AGENDA

The Columbia Architectural Design Review Team will meet on Tuesday, December 13, 2022 at 9:00 AM in Conference Room A on the basement level of City Hall, 700 N. Garden Street. The Planning Commission will consider the following:

City of Columbia
ARCHITECTURAL DESIGN REVIEW TEAM
November 8, 2022

Arden Apartments II
STACKED FLATS "BLDG A/3"
LOTS 209 & 210
2401 ARDEN VILLAGE DRIVE
COLUMBIA, TN 38401

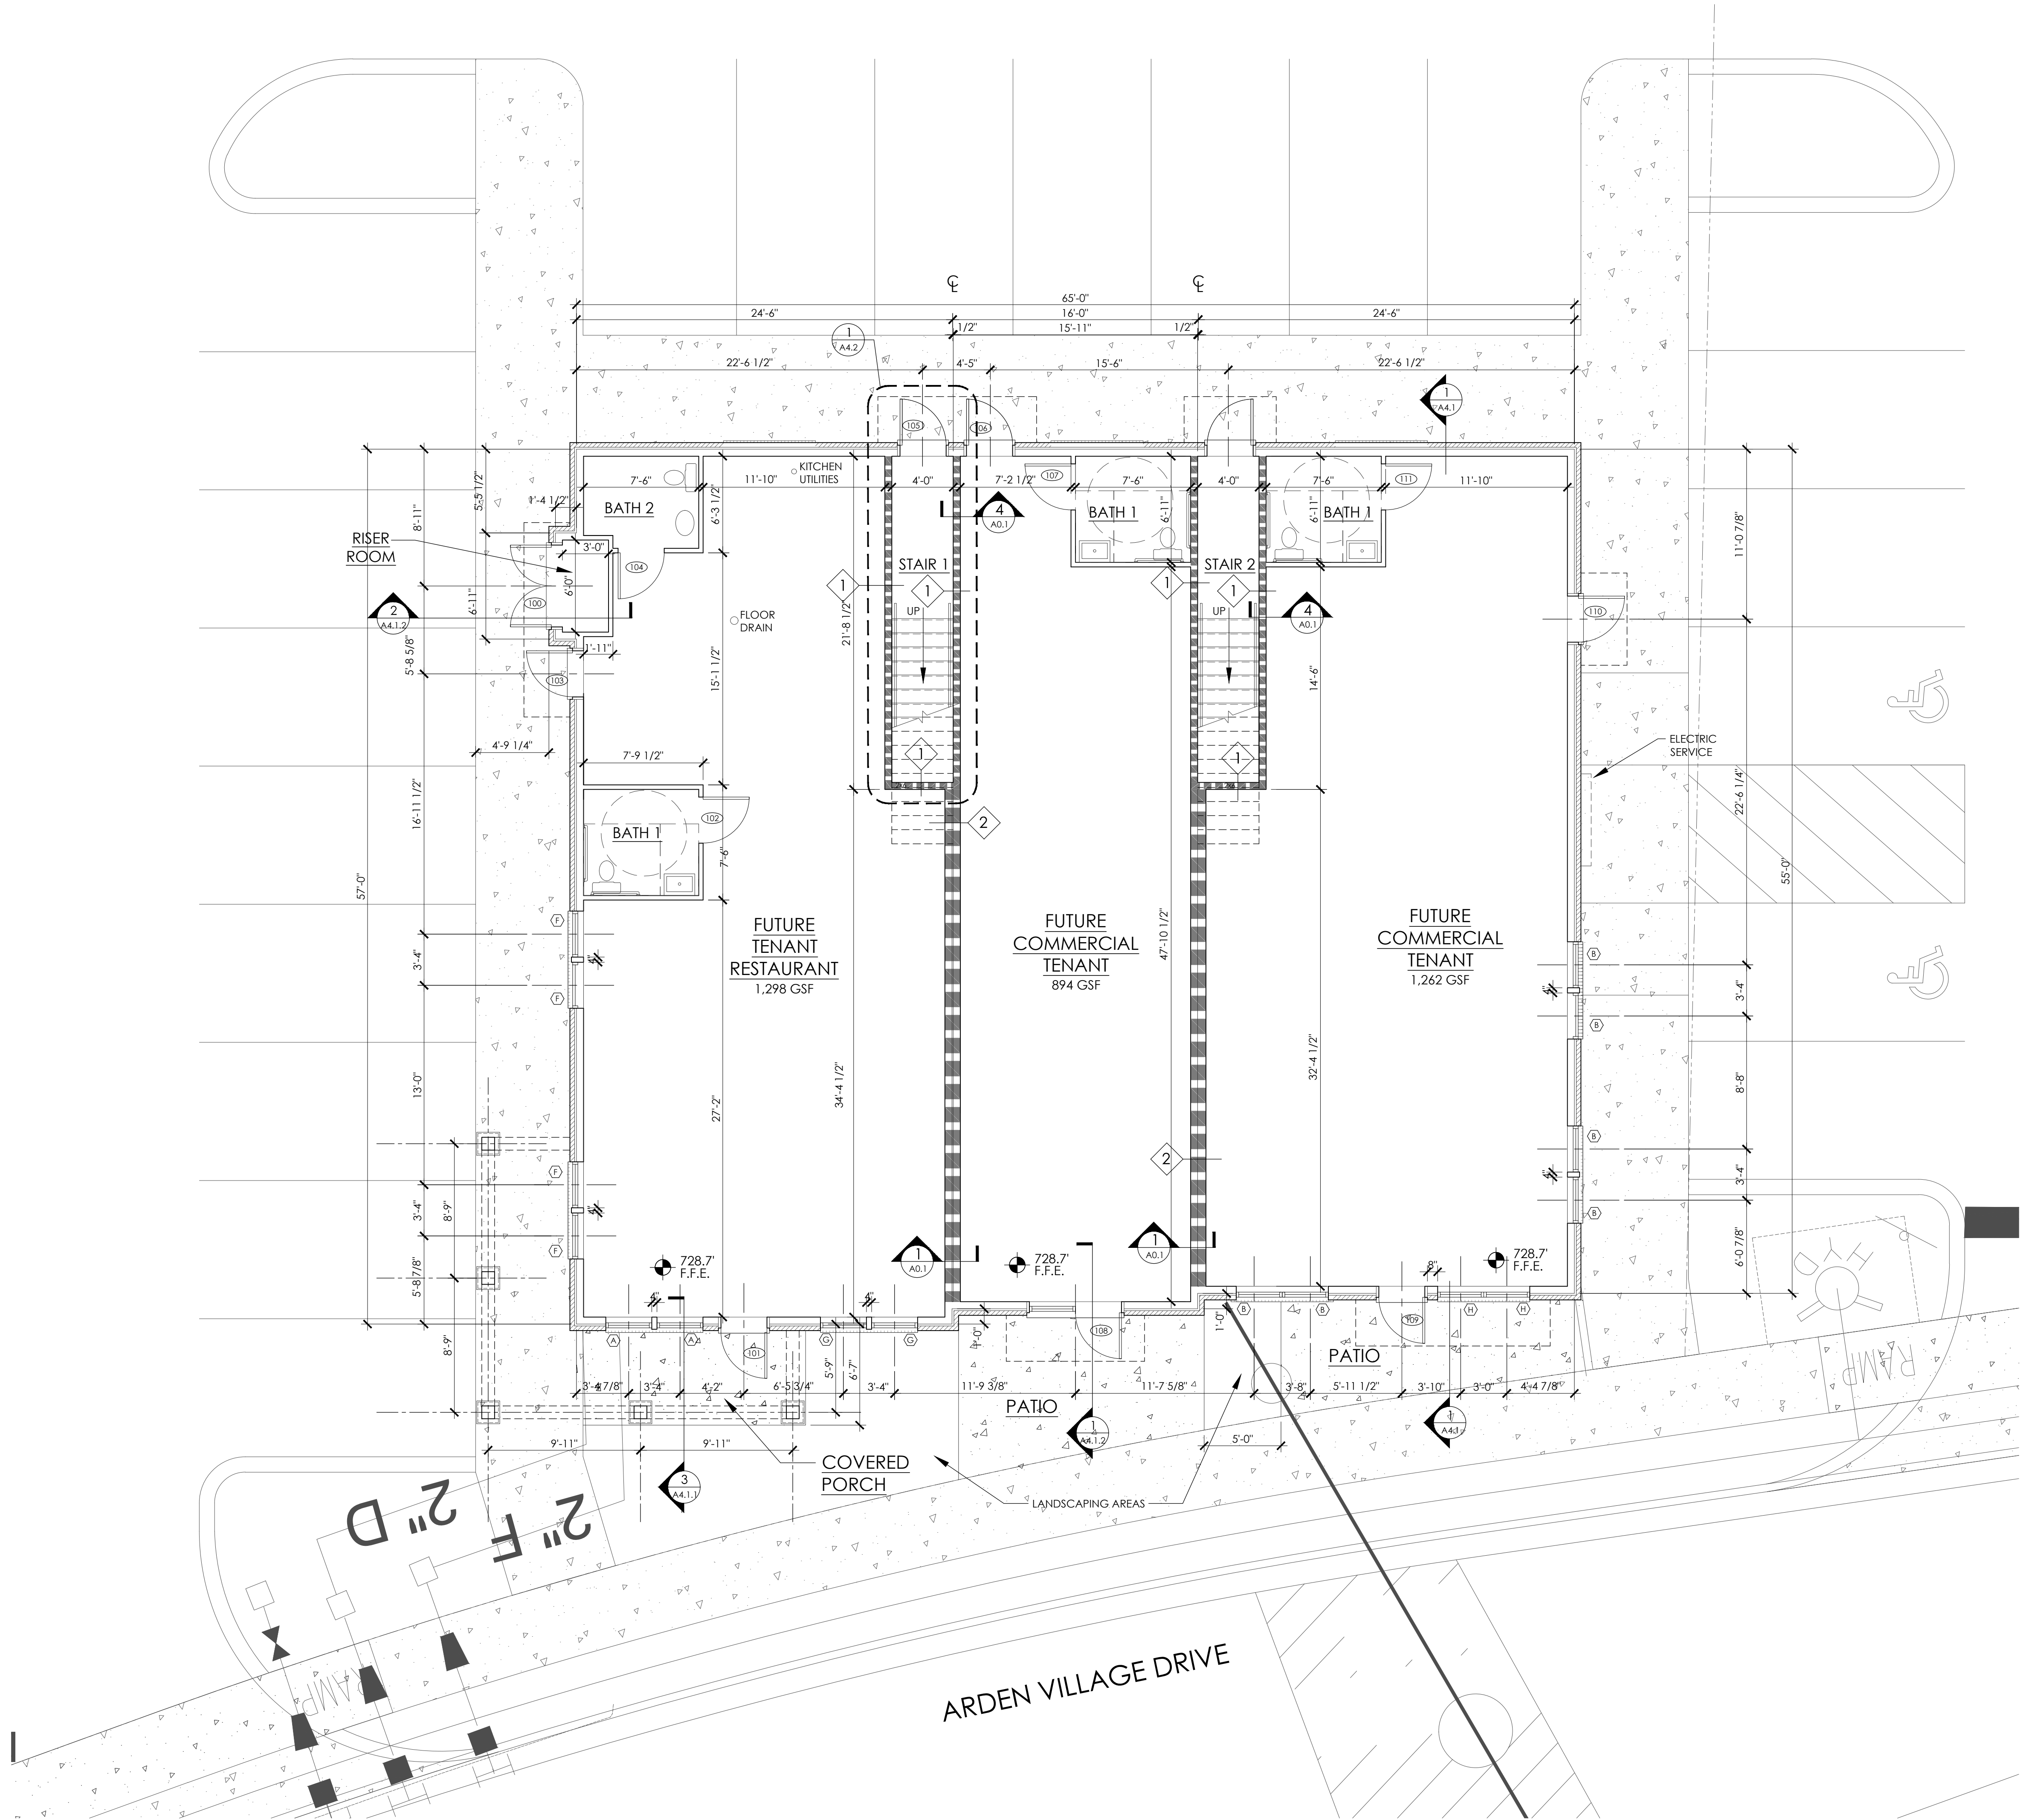
This proposed three story multi-use building adheres to the design standards for a PUD as described above with the primary façade material being brick accented by fiber cement board and articulation within the front façade by the use of large windows and building insets.

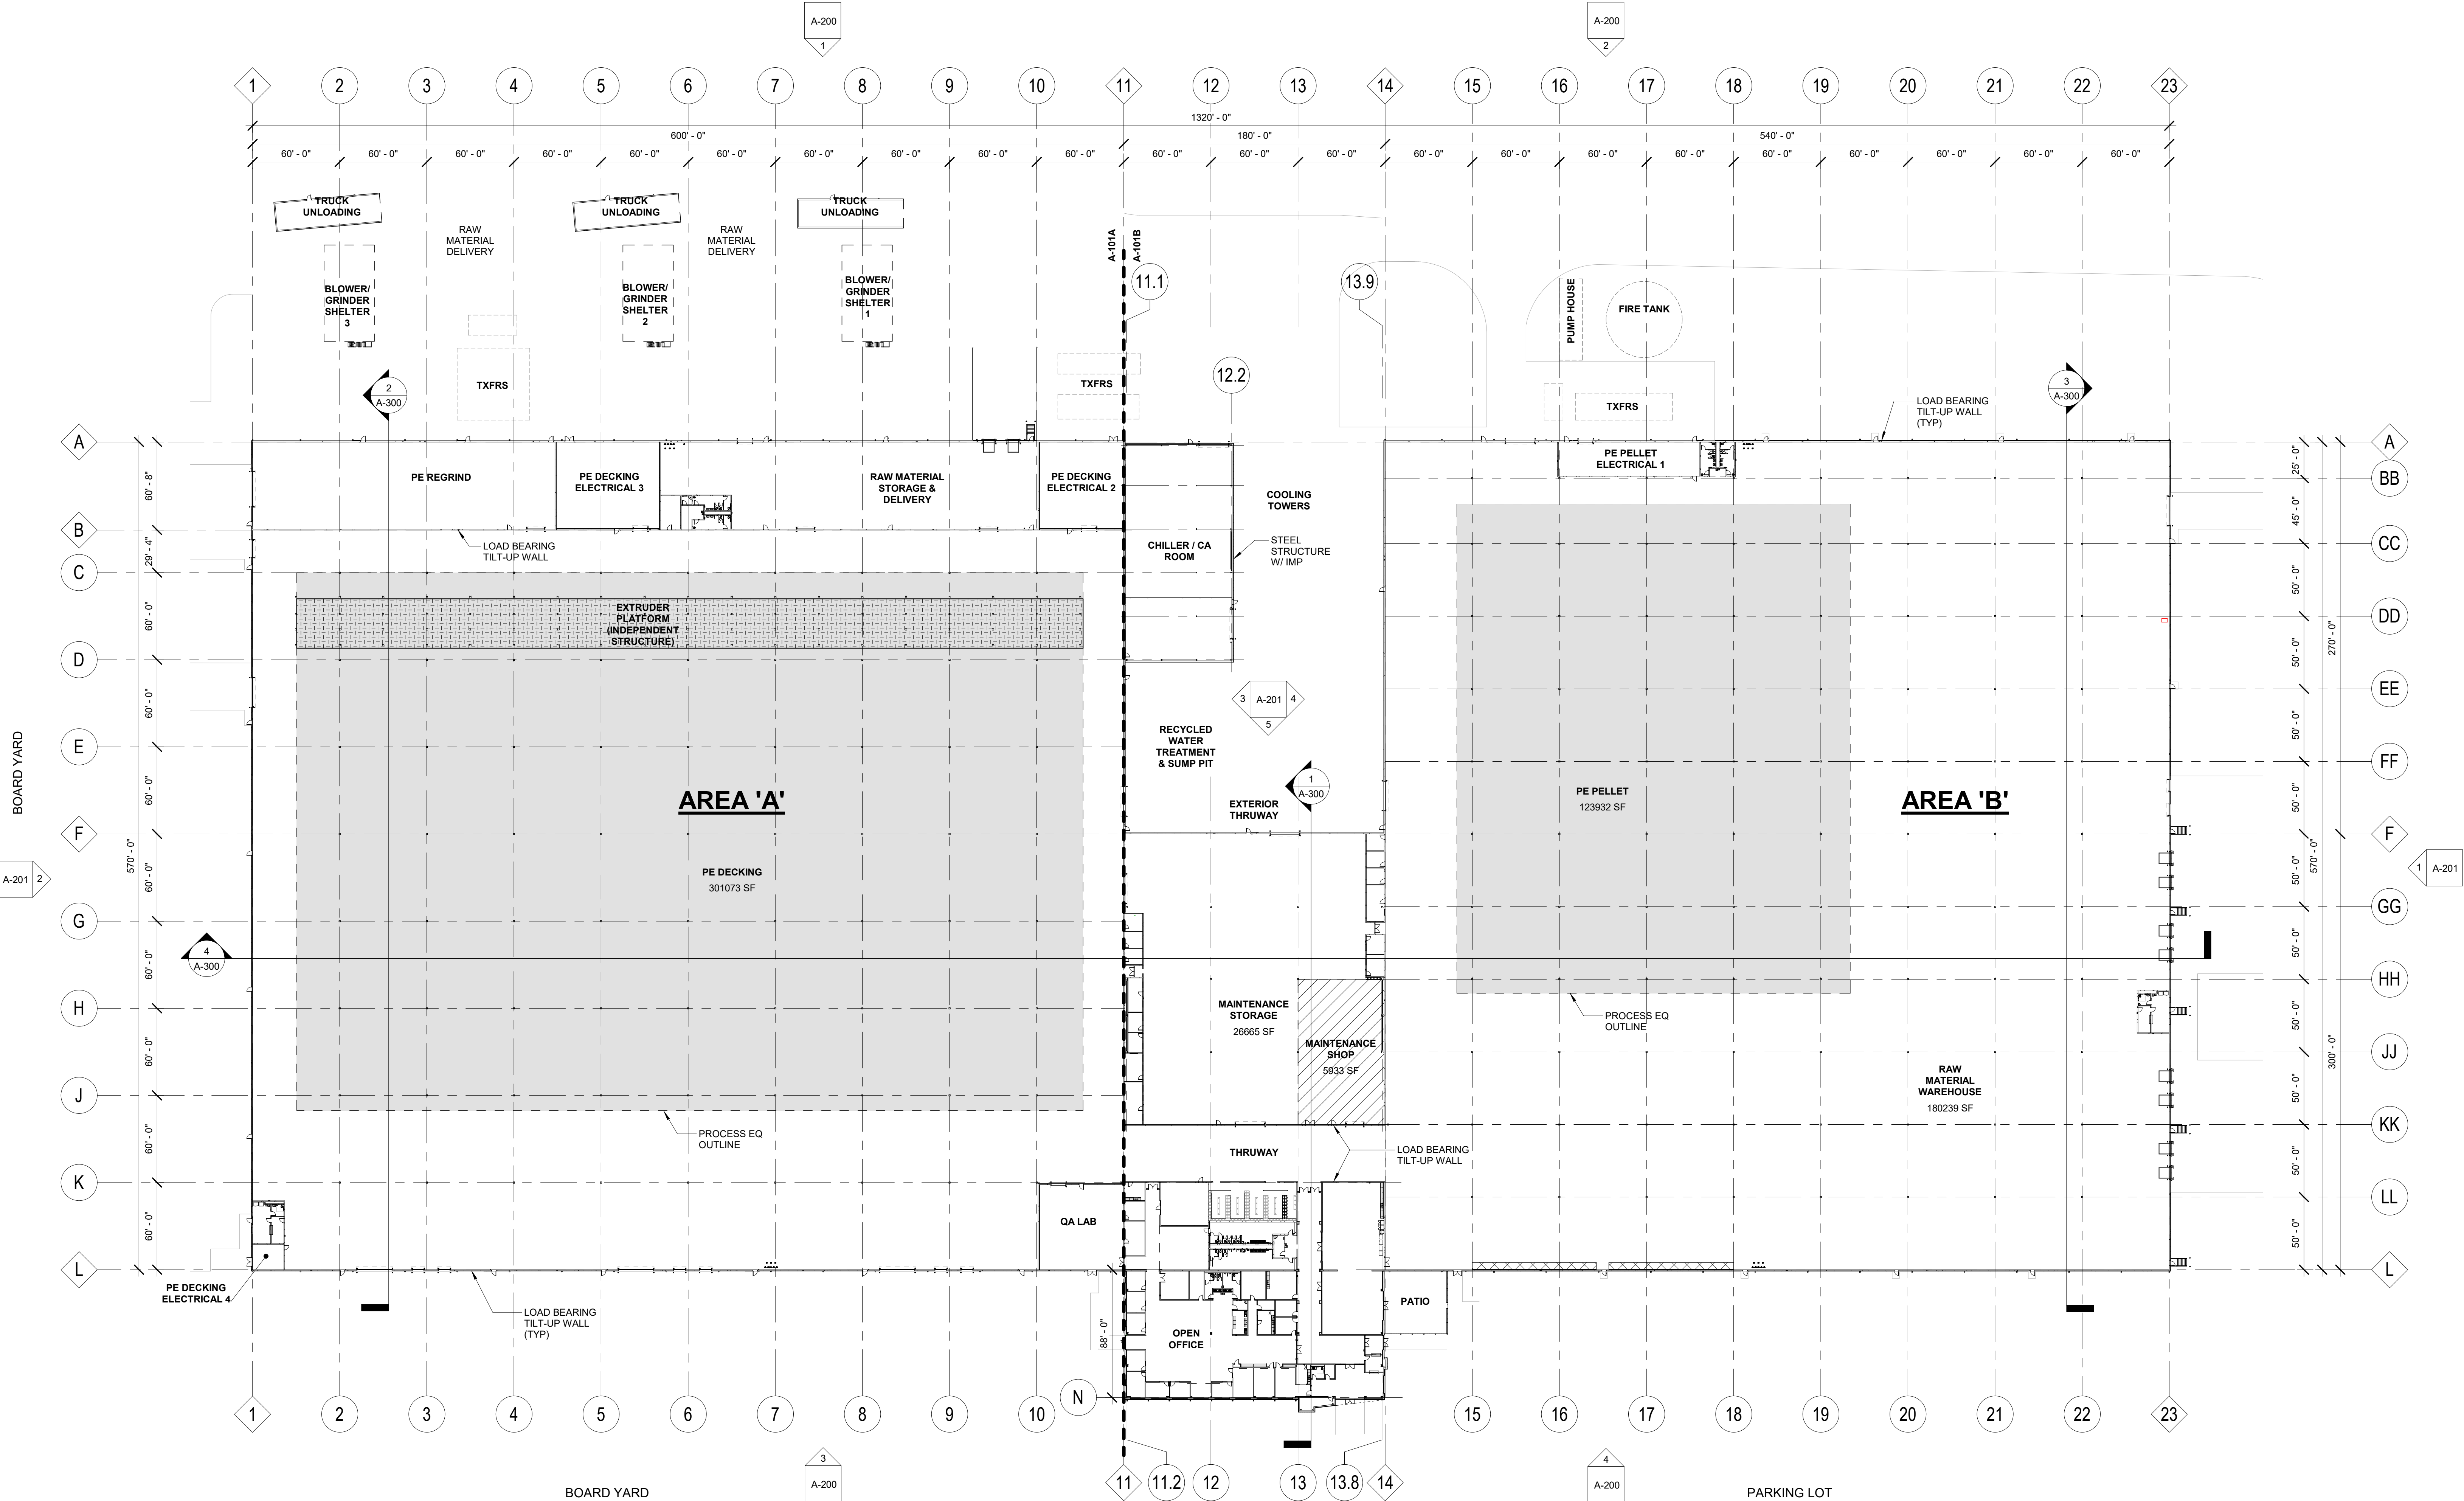
Overall façade material will consist of a concrete tilt wall on all elevations. The south elevation (Primary entrance) will have a front building addition with a metal cladding with a fiber cement cladding nearest to the facilities primary entrance. It was noted in the application that there will be addition silos located at the rear of the structure with little to no visibility from Hwy 43.
